**May 10, 2012**

Re: Contractor Questions on 636A6-11-102 Correct Fire Deficiencies

Des Moines VAMC  
Correct Fire Deficiencies  
Addendum

AS-4

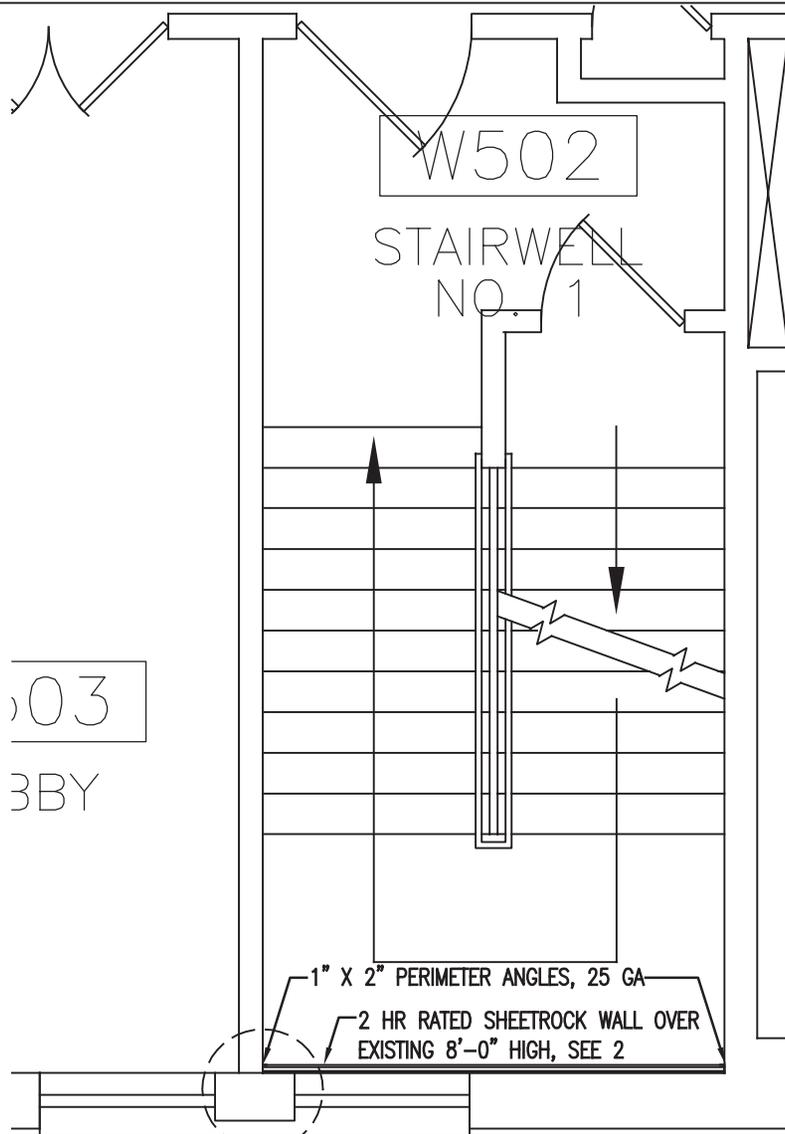
**Item 21: On page 4 of 22 there are several doors with flag notes calling out new doors not on the door schedule. 130, 133a, 134.2, 134.1, w128, 159, 123. Notes for 1228, 1376, 1382, 1390, 1503, 1711? On door schedule not seeing any note.**

Refer to Sketch AS-4 to correct one door tag.

AS-1

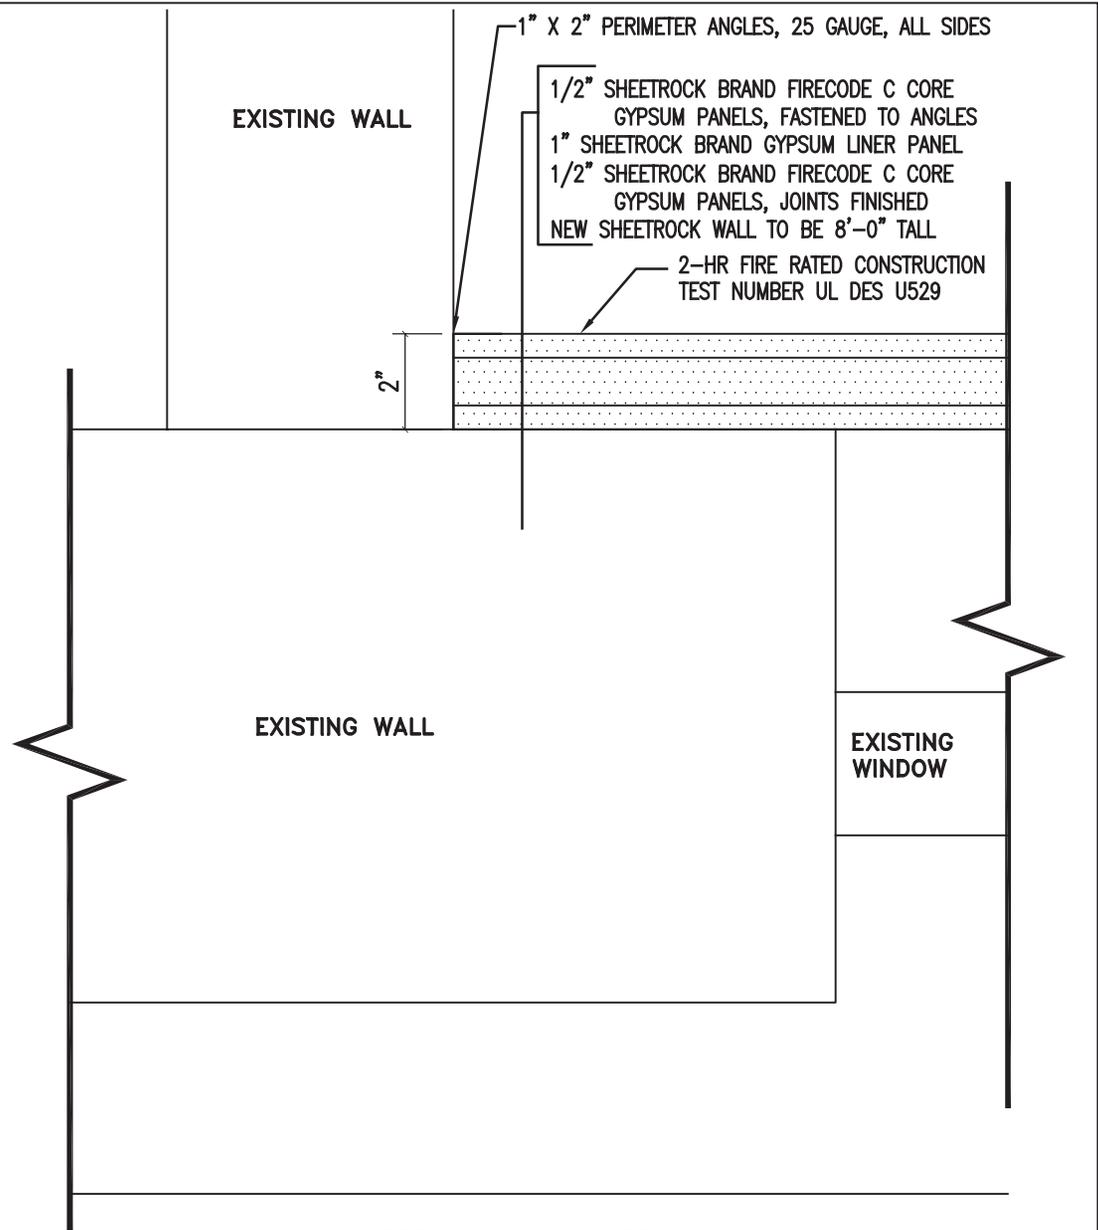
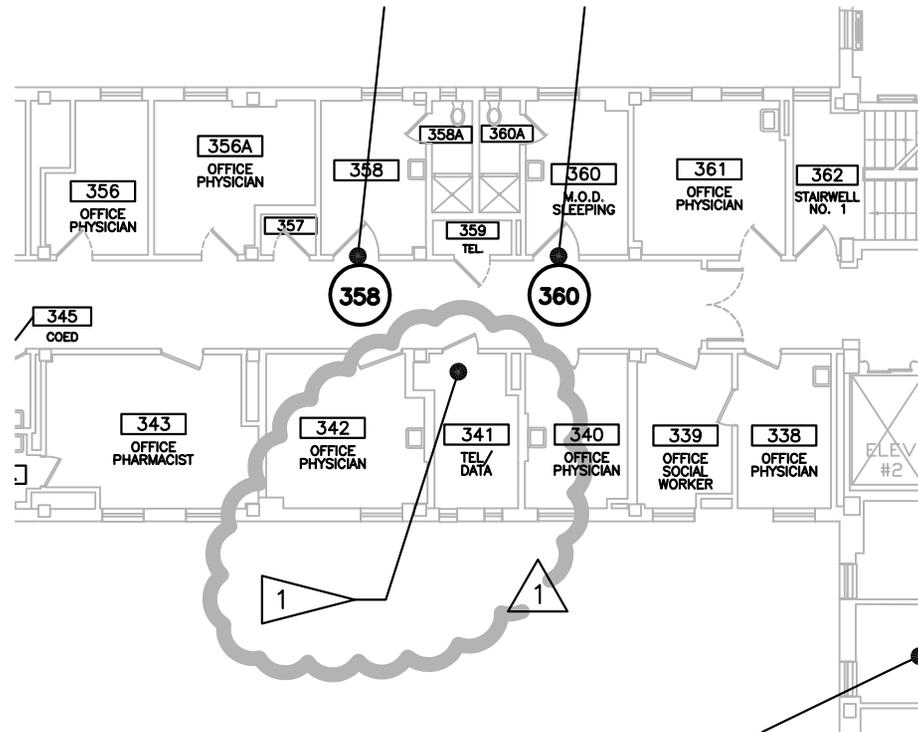
- Item 3: Please provide detail of existing construction of the shaft to receive the 2 hour partition. Or, please let me know when we can take a look at access in/out of this space. We will need to know if scaffolding will be feasible or if another work surface will be needed.**  
See attached Sketch "AS-1".

1 Stairwell No. 1 - Building 1W - Level 5  
SCALE: 1/4" = 1'-0"

2 SHEETROCK WALL DETAIL  
SCALE: 3" = 1'-0"

AS-2

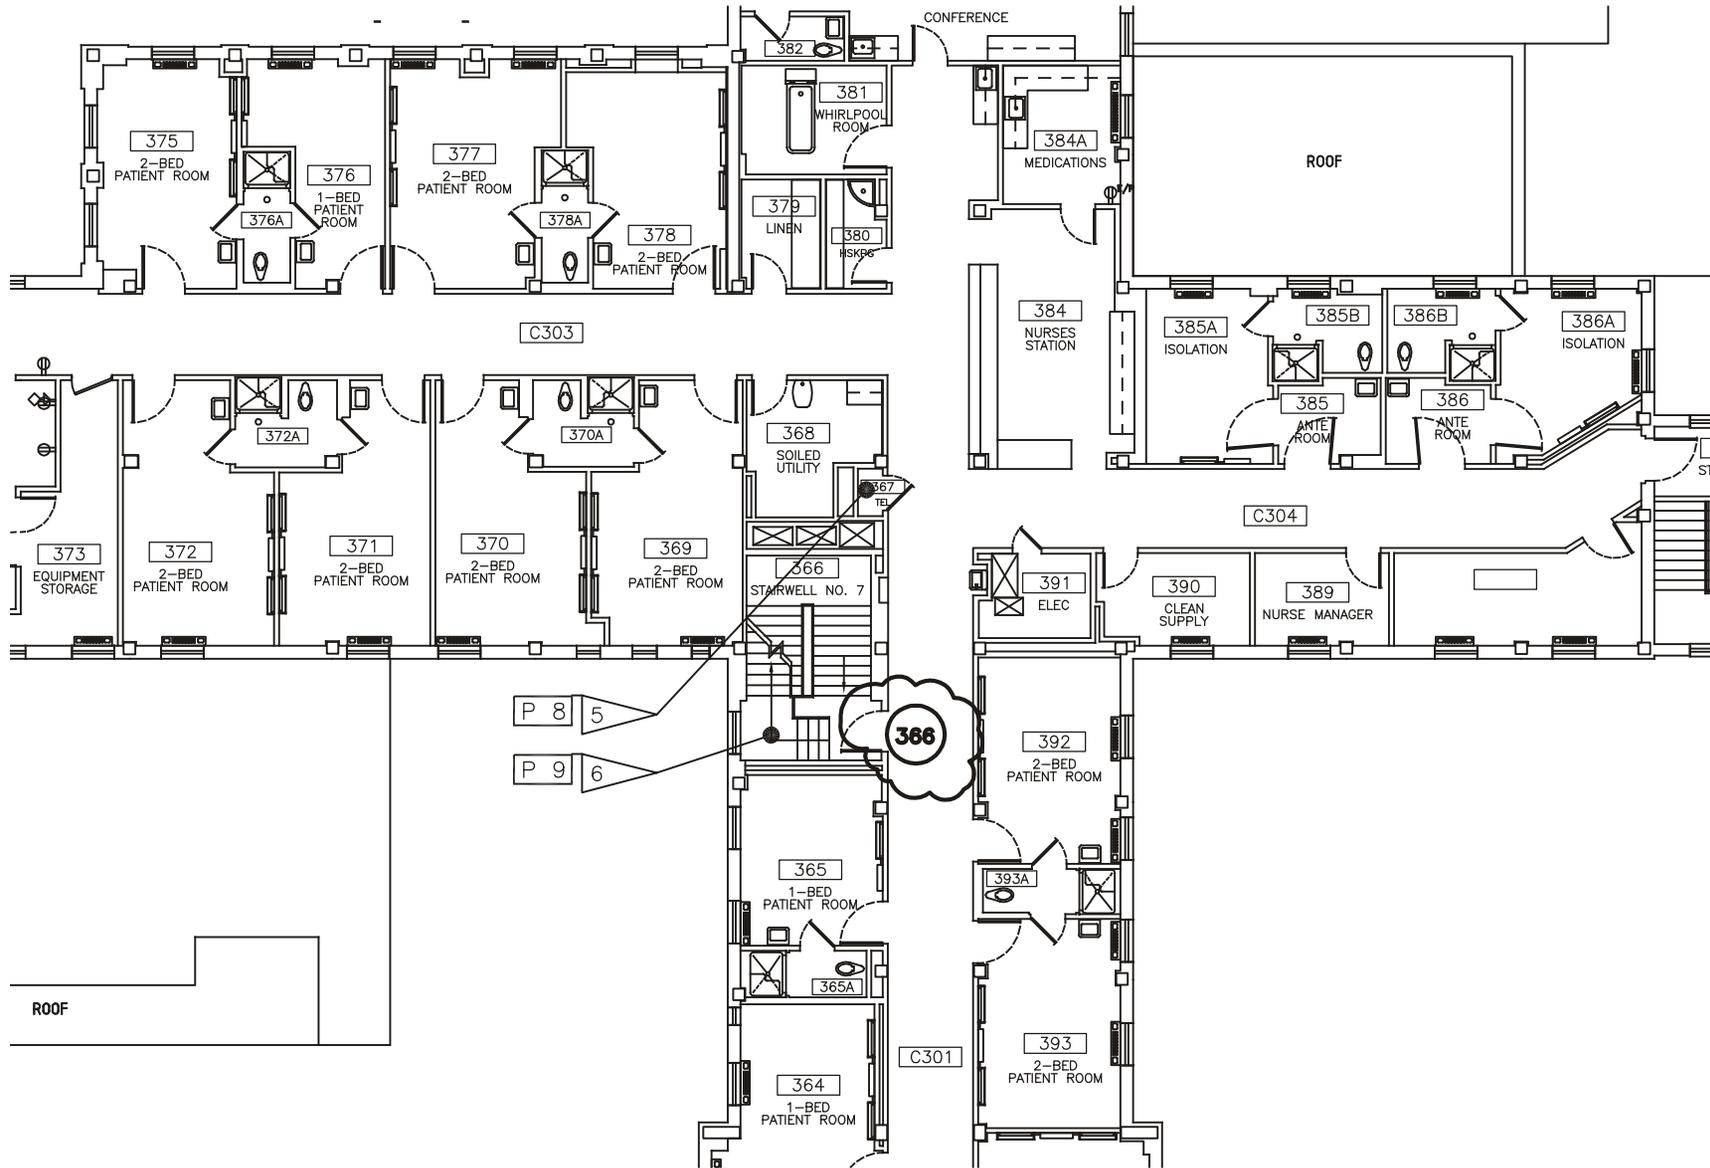
**Item 20: Two additional rooms have been located that have penetrations that need to be sealed.**

Refer to Sketches AS-2 and AS-3 to add this work to the scope of the project.
